ADDENDUM NO. 5
NEW SOFTBALL COMPLEX FOR TRUSSVILLE CITY SCHOOLS
Architect Job No. 23-72
April 17, 2024
DCM # 20240224

The Plans and Specifications are here by amended. The following supersedes all contrary and/or conflicting information and is made part of the contract documents.

JOB NO. **23-72**
 SHEET NO:
C0.1

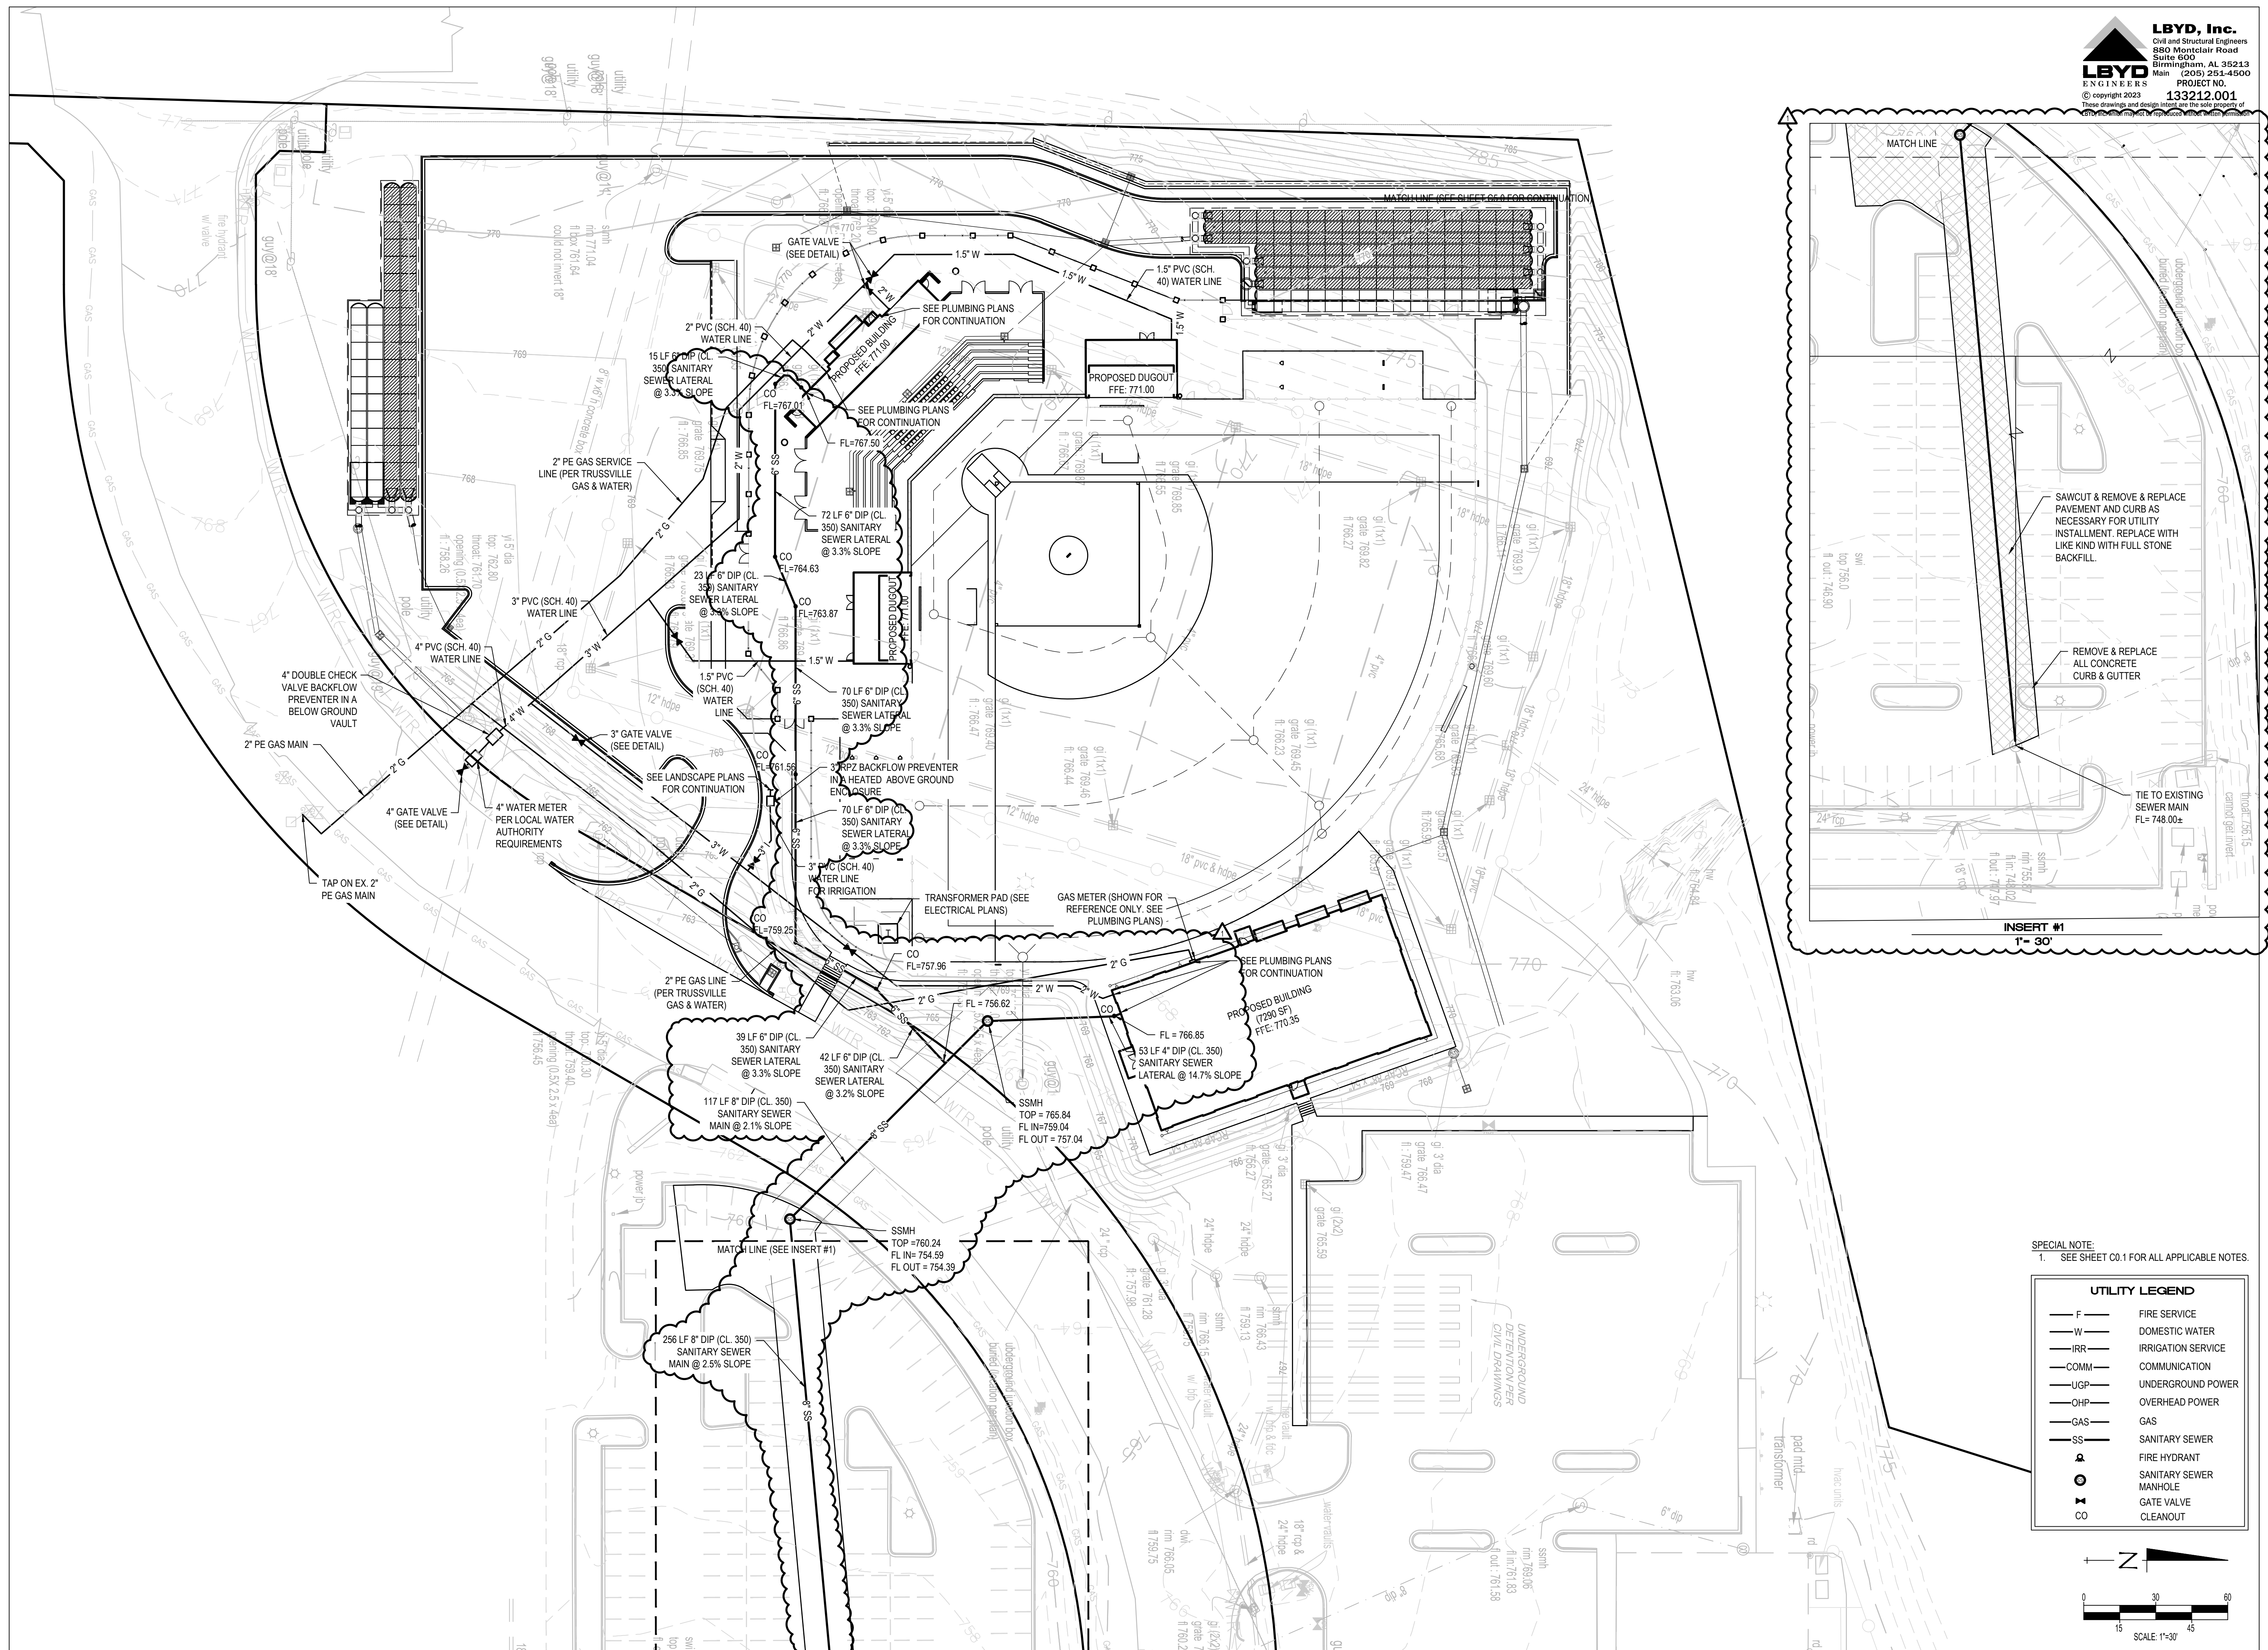
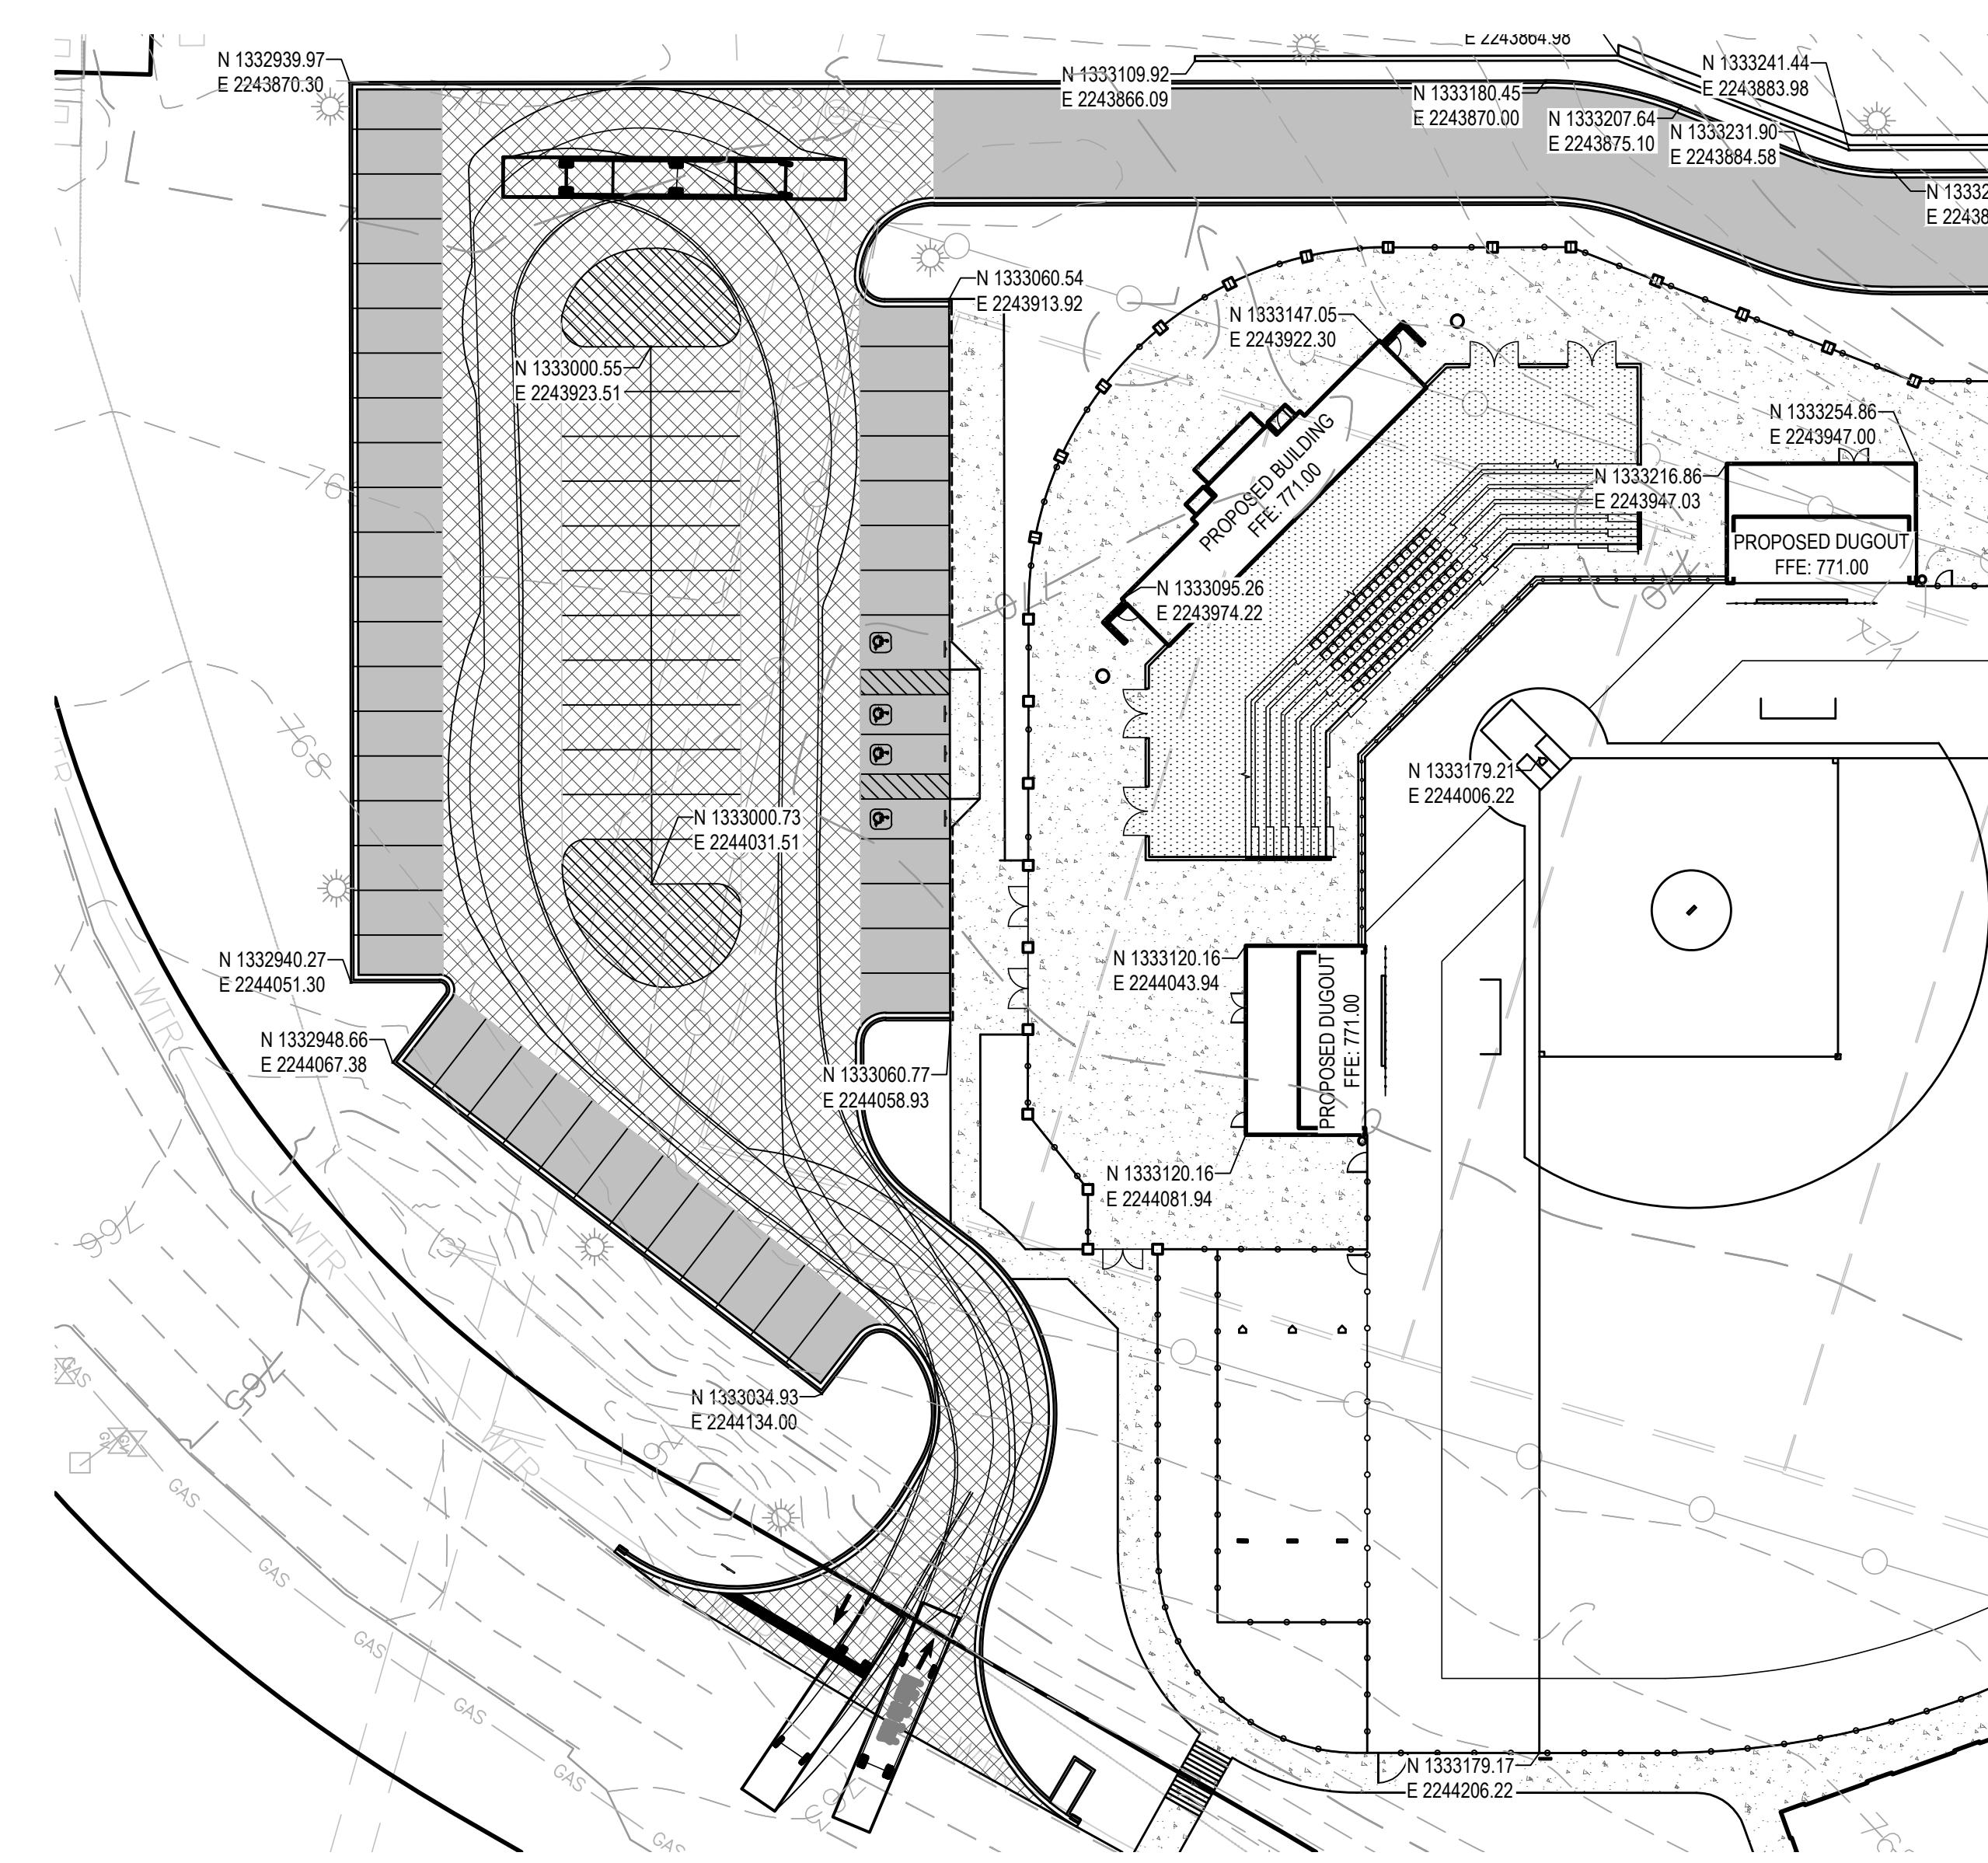
- 1. See the attached REVISED Sheet **C0.1** for revisions to Civil Notes.
- 2. See the attached REVISED Sheet **C5.0** for revisions to Site Utility Plan.
- 3. See the attached REVISED Sheet **C5.1** for revisions to JCES Plan & Profile.
- 4. See the attached REVISED Sheet **A2.5** for revisions to Door and Window Schedule and Details changed finish and operation of coiling service door on the schedule.
